Re: St. Lucie Plant Unit 2
Docket No. 50-389
Renewed Facility Operating License No. NPF-16

Response to Request for Additional Information Identified During Audit of the Reactor Systems Branch (SRXB) Fluid System Analyses for the Extended Power Uprate License Amendment Request

**Response to Request for Additional Information
Identified During Audit of the EPU LAR
Reactor Systems Branch Fluid System Analyses**

Figure 1
Energy Addition Temperature Sensitivity
PORV Mitigated Transient with PORV Setpoint = 490 psia

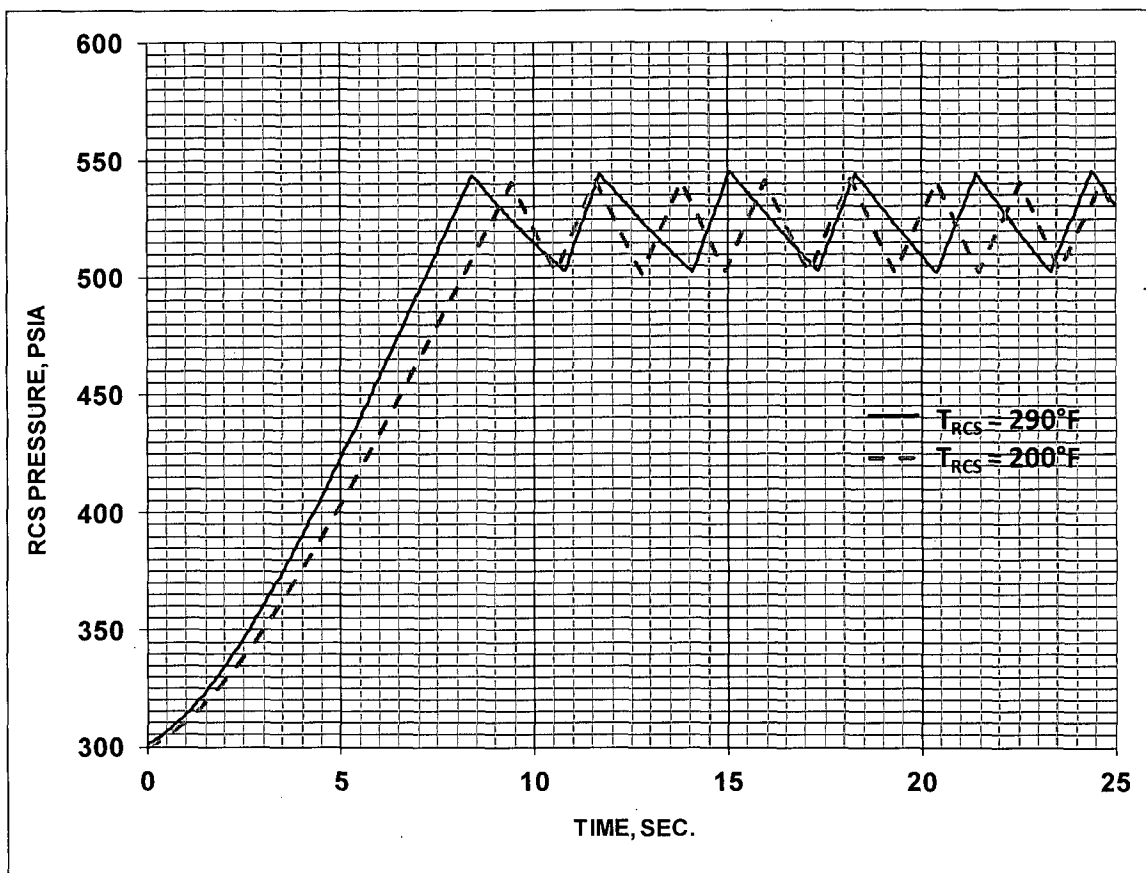
- 1. Describe the methods used to perform the LTOP transient analysis, if possible refer to previously submitted and approved documents.**
- 2. Demonstrate that limiting initial pressures and temperature values are used in the transient analyses across the full range of LTOP conditions.**

The initial temperature used for the energy addition transients is 290°F (Reference 1, Enclosure 1, Section 3.3-1) which bounds the LTOP enable temperatures of 246°F during heatup and 224°F during cooldown (EPU LAR Attachment 3, Table 3.4-3). The energy addition analysis uses the decay heat value determined for the mass addition transient. Since the rate of change of specific volume with temperature increases with increasing temperature, a higher temperature is conservative. This was demonstrated explicitly by running an additional energy addition case with an initial RCS temperature of 200°F. The

results are shown in Figure 1. The 200°F initial RCS temperature case resulted in a lower peak pressure than the 290°F initial temperature case.

Figure 2
Transient Result / Pressure-Temperature Limit Comparison
(Heatup)

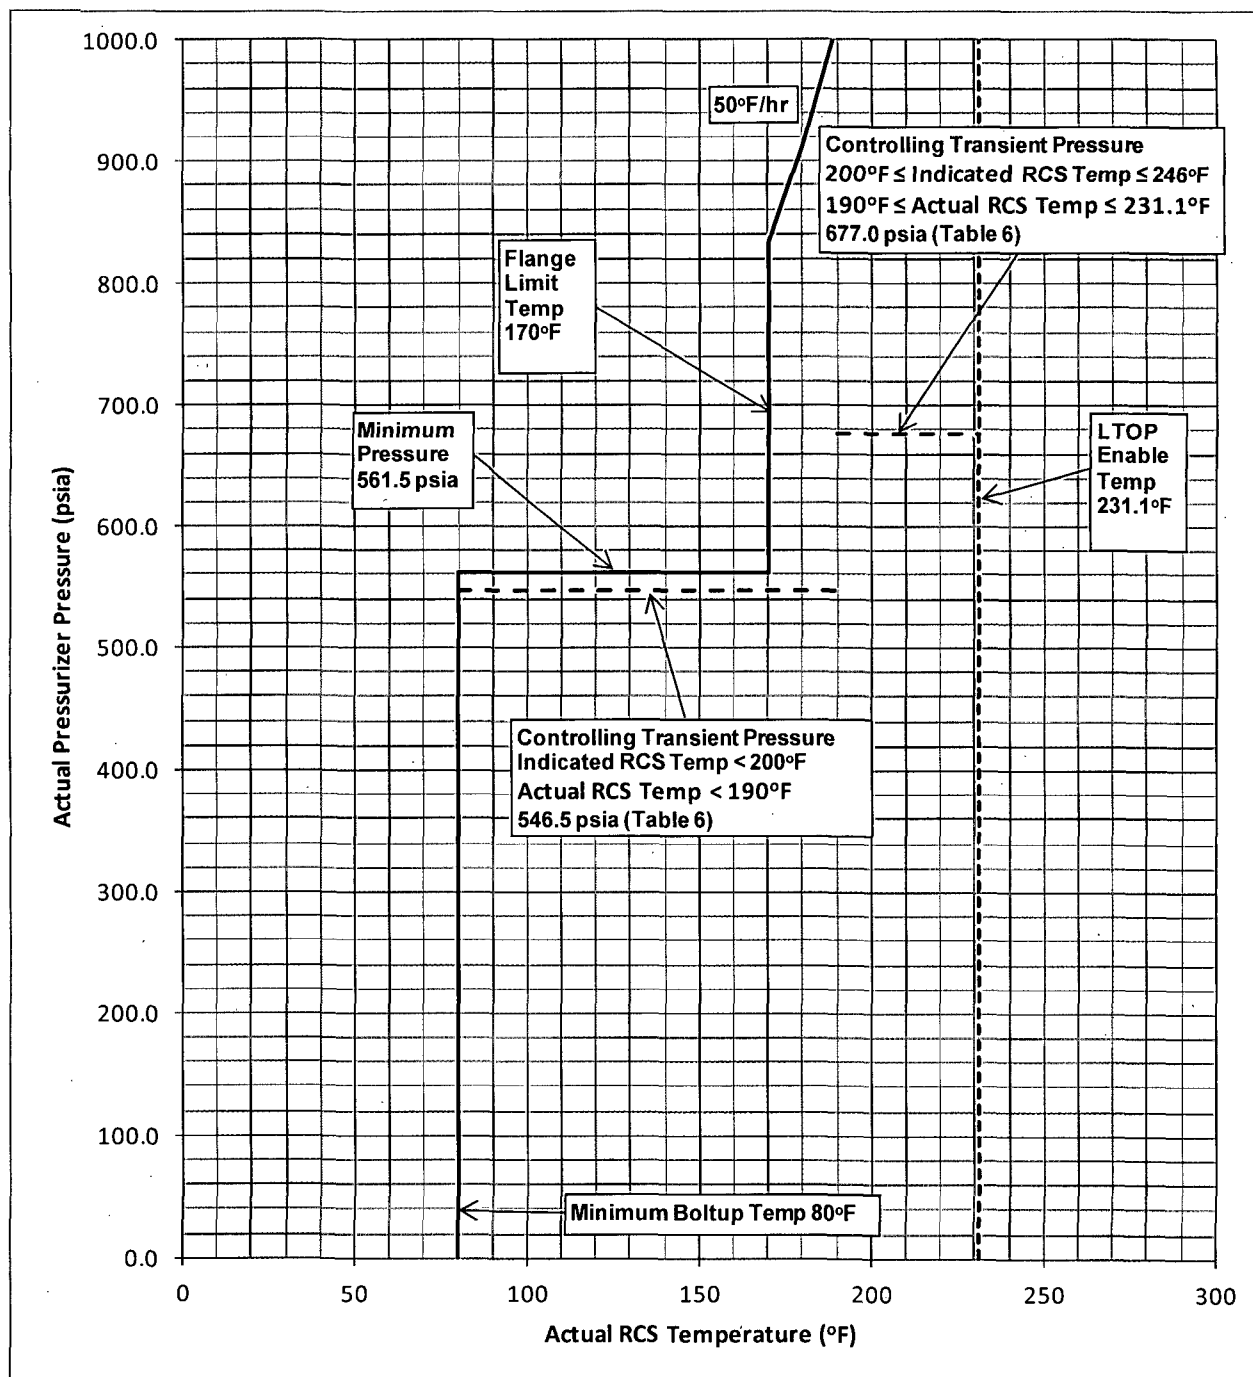
- 5. Describe how LTOP transient results are compared to the Appendix G Pressure-Temperature (P-T) limits. Include descriptions of:**
 - a) Applicable Technical Specification (TS) controls and how they relate to the range of applicability of the various LTOP transient results. Specifically over what temperature ranges are the various transient results applicable.**

Figure 2 shows a comparison of the controlling transient pressures from Table 6 with the P-T limits for heatup. Composite heatup P-T limits were created from Table 3 of Enclosure 1 of Reference 1, allowable heatup rate from EPU LAR Attachment 3, Figure 3.4-2, minimum pressure limit, minimum boltup temperature, and flange limit temperature from Section 2.7 of Enclosure 1 of Reference 1, and LTOP enable temperature without instrument uncertainty of 231.1°F for heatup. By inspection of Figure 2, it can be seen that the LTOP transient pressures are below the P-T limits for the entire LTOP temperature range.
